## **MCB Issue List Regarding APR-1400, DCD Tier 2, SECTION 10.4.8**

### **Issue #1 (AI 10-12.1)**

Figure 10.4.8-1 Steam Generator Blowdown System Flow Diagram (2 of 2)

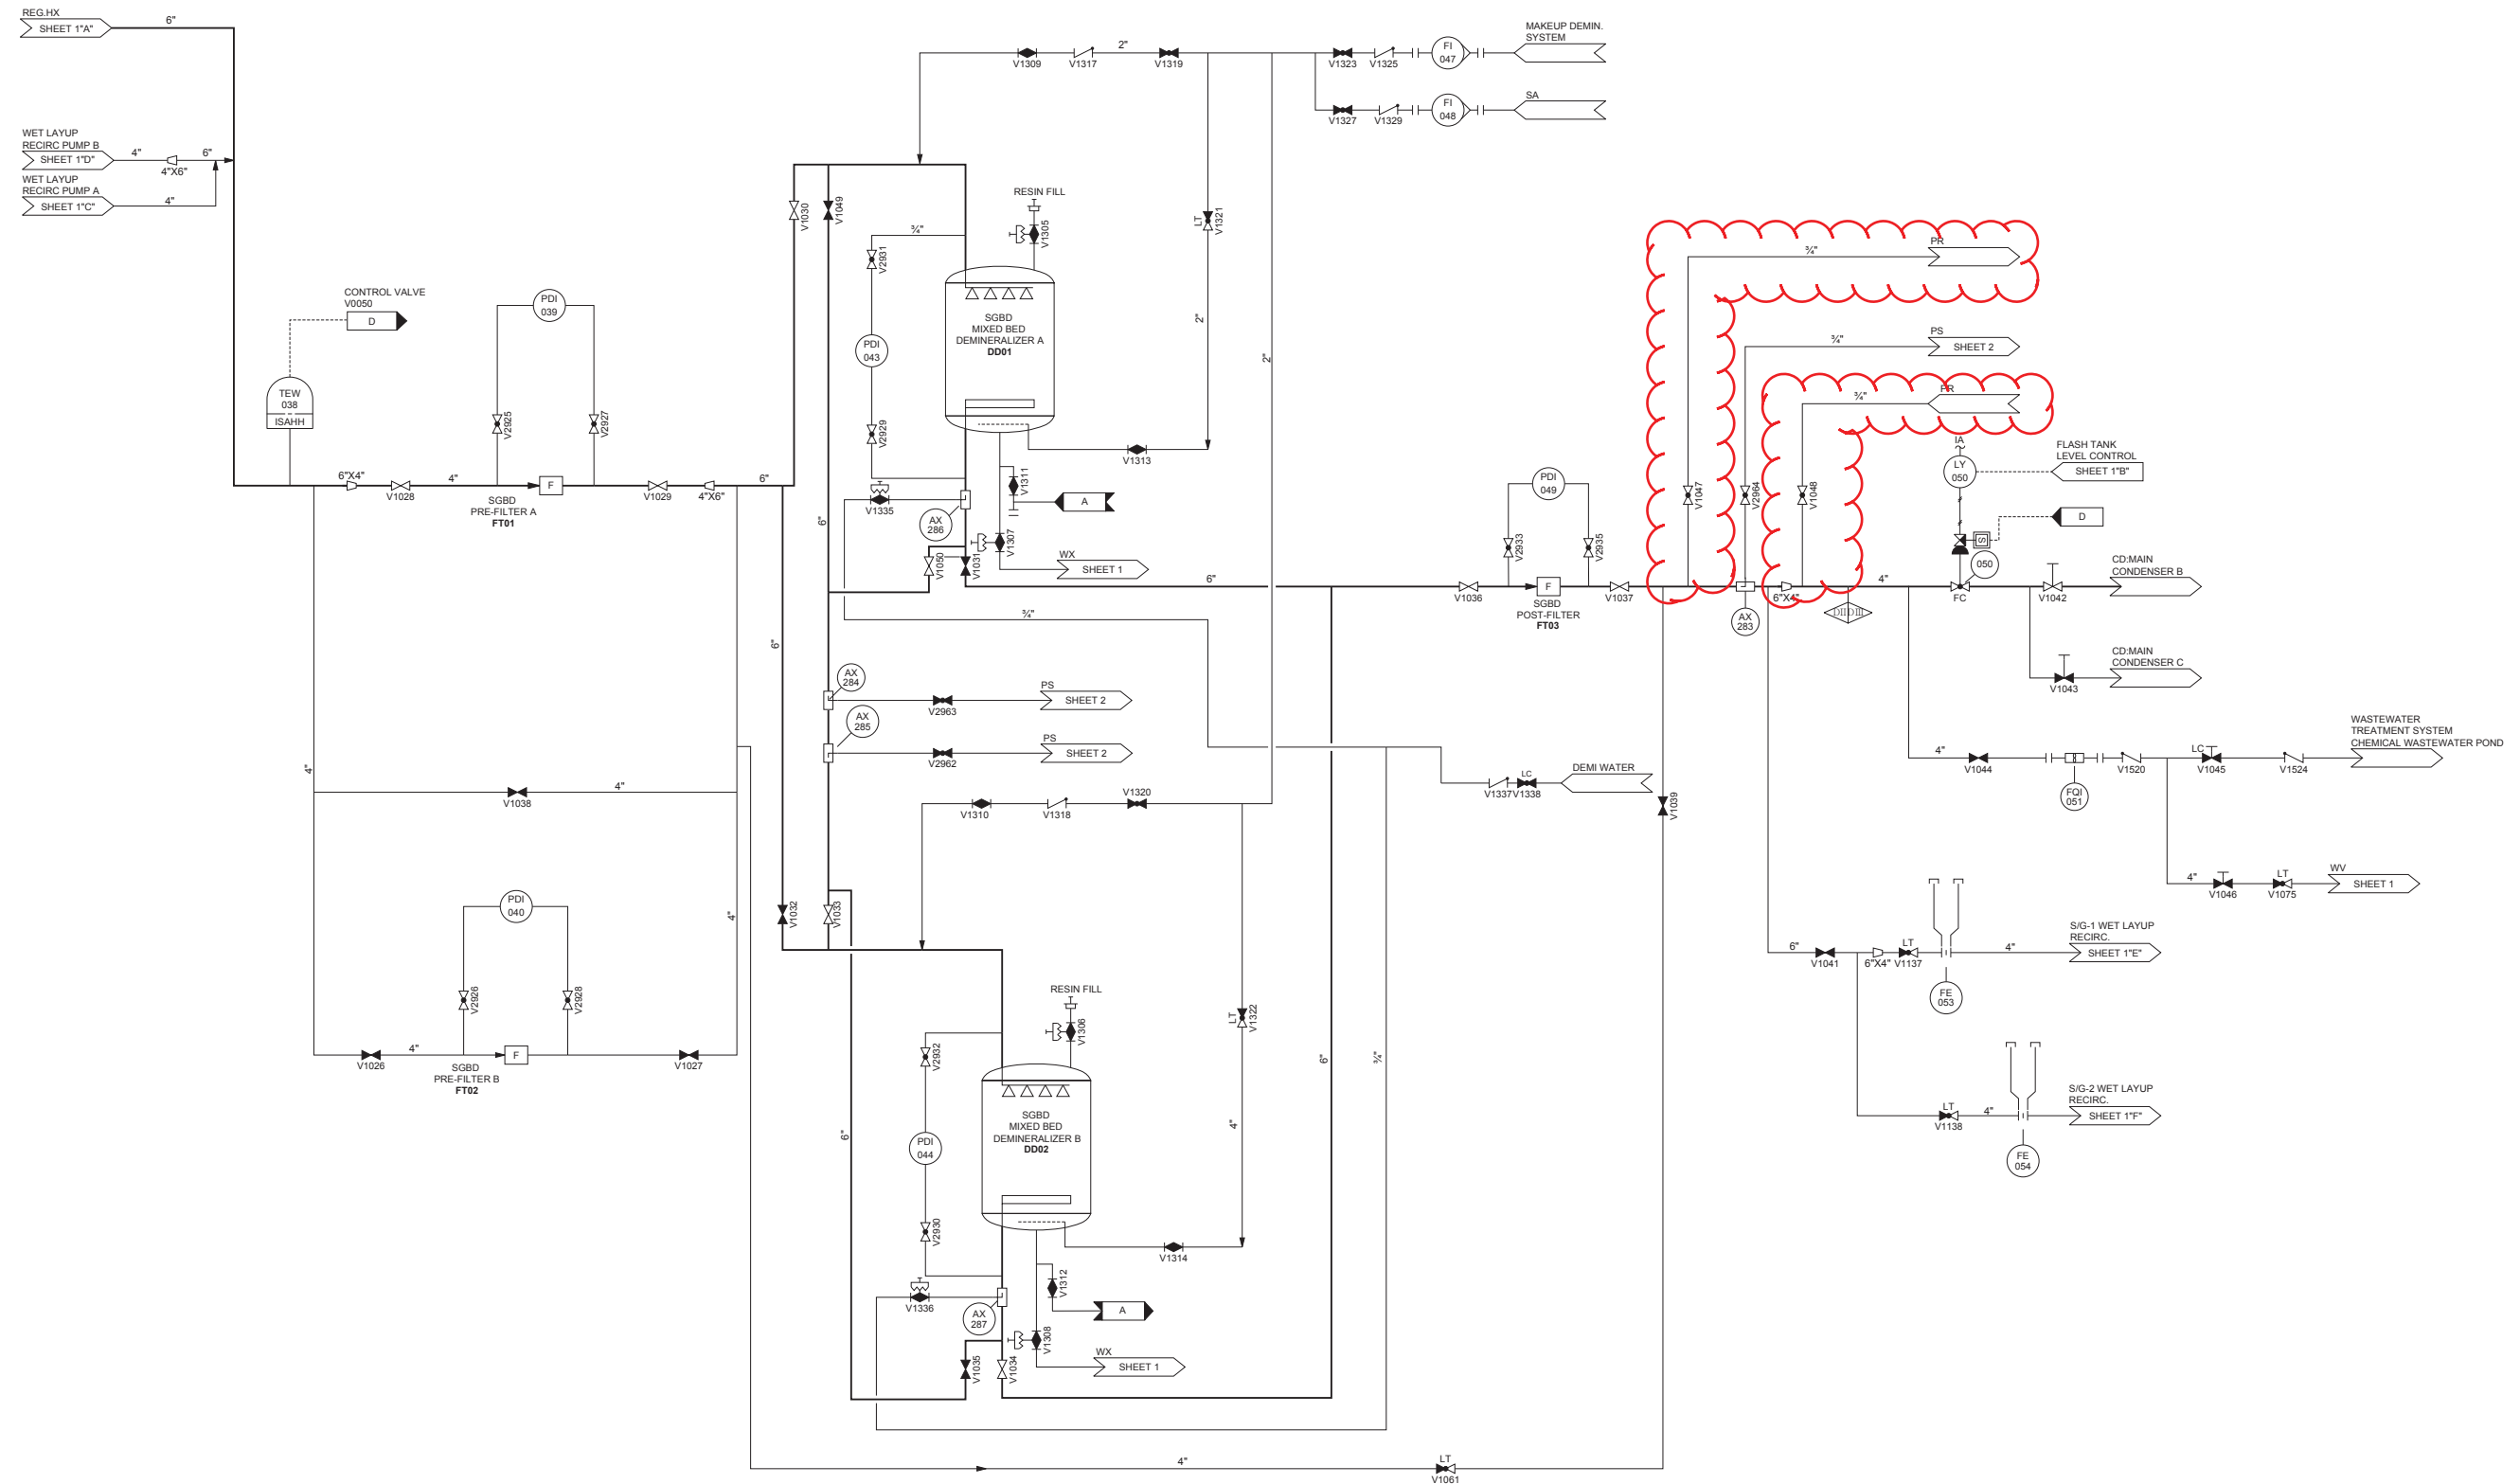
FSAR Subsection 10.4.8.2.3.5, Item c, refers to high radioactivity measured at the SG blowdown demineralizer outlet. The staff was not able to identify a radiation monitor at this location in the figures (FSAR Figure 10.4.8-1).

Revise FSAR Subsection 10.4.8 to provide more information about these measurements, including the designation and location of the radiation monitors.

The designation for the radiation monitor is located in the Figure 10.4.8-1 as shown in the attachment 1. The location of the radiation monitors is described in Subsection 10.4.8.5 as shown in attachment 2.
